Modification Recommended Service Note

N8925A - Autoranging System DC Power Supply, 80V, 340A, 10000W, 208 VAC

Serial Numbers: DE14290000 - DE15369999 without manufacturing ID Version "B"

The Problem:

5) SMT resistors R93/94 are located in red circle shown below:

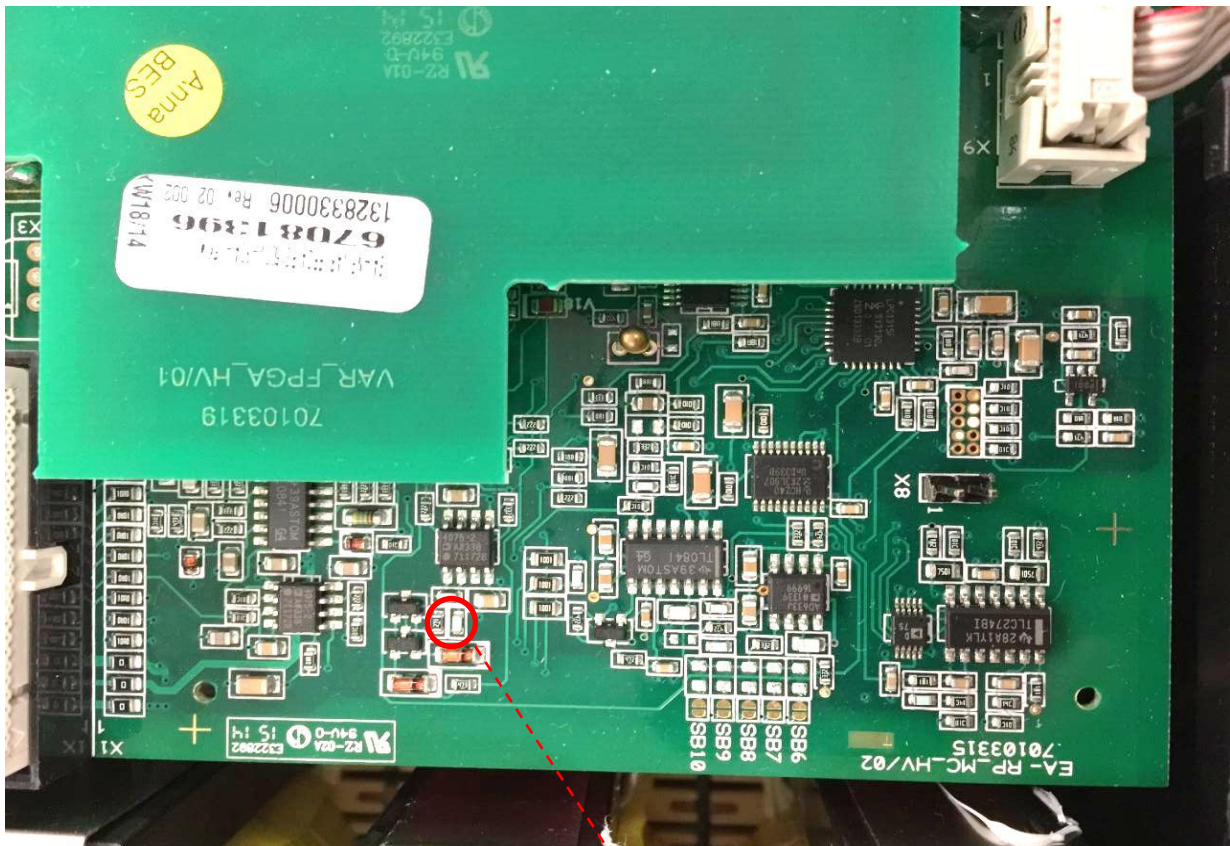
Removal of two (2) surface mount resistors, R93 and R94, will correct this problem:

6) After removal of R93 & R94, re-install all covers. Instrument does NOT require recalibration after the removal of R93 & R94.

Suffix “B” added

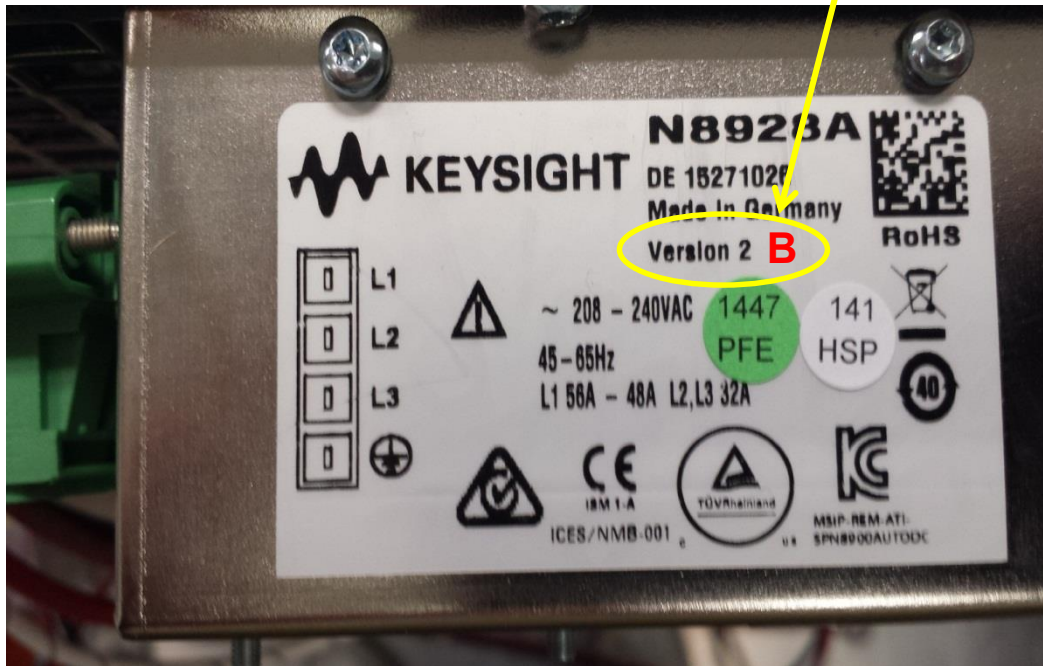
7) On the acMains label, on the rear of the instrument; use an indelible marker, to add the suffix letter “B” after the Version ID. This will assist in the tracking of modified instruments.
